RENESAS TECHNICAL UPDATE

Product Category	SOC		Document No.	TN-RE*-A0007A/E	Rev.	1.00
Title	Correction of errors and addition of electrical characteristic items in RE01Group User's Manual:Hardware		Information Category	Technical Notification		
Applicable Product	RE01 Products with 256-Kbyte Flash Memory	Lot No.	Reference Document	RE01 Group User's Manual:Hardware Rev.1.00 (R01UH0894EJ0100)		
		All

This document describes corrections and additions to the RE01 Group User's Manual: Hardware, Rev.1.00.
The corrections are indicated in red.

[Setting the security MPU registers required to prohibit the ALerASE command]

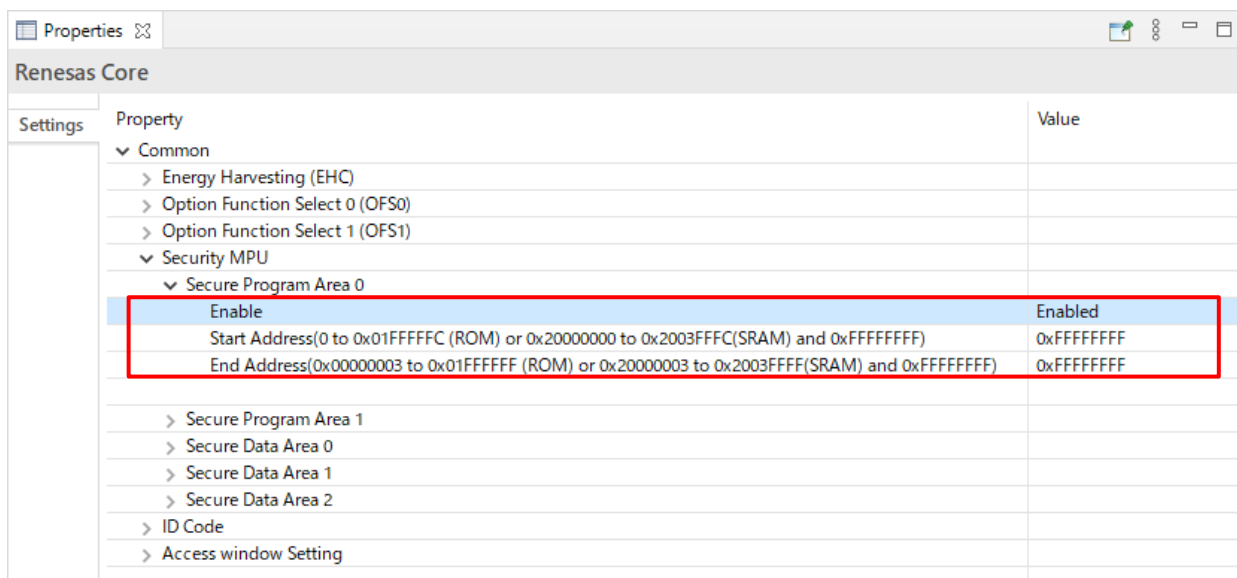
(3) Measures to prohibit the ALerASE command when using the RE Software Development Kit
 When all the following conditions are met, it is necessary to set the security MPU registers to prohibit the ALerASE command.

[Conditions]

- Bit 127 of the OSIS register is set as 0.
- The AWS.FSPR flag is set as 1.
- Do not use the security MPU.

- SECMPUAC = 0xFEFF
- SECMPUCS0 = 0xFFFF_FFFF
- SECMPUCE0 = 0xFFFF_FFFF

The following shows how to implement [Setting the security MPU registers required to prohibit the ALerASE command] when using the RE Software Development Kit (Driver Configuration Tool, CMSIS Driver Package).

A) When using Driver Configuration Tool

- ① From the Configuration Editor window, open the properties of “Renesas Core”.
- ② Open “Common” > “Security MPU” > “Secure Program Area 0” and set the following values.
 - Enable: **Enabled**
 - Start Address: **0xFFFFFFFF**
 - End Address: **0xFFFFFFFF**
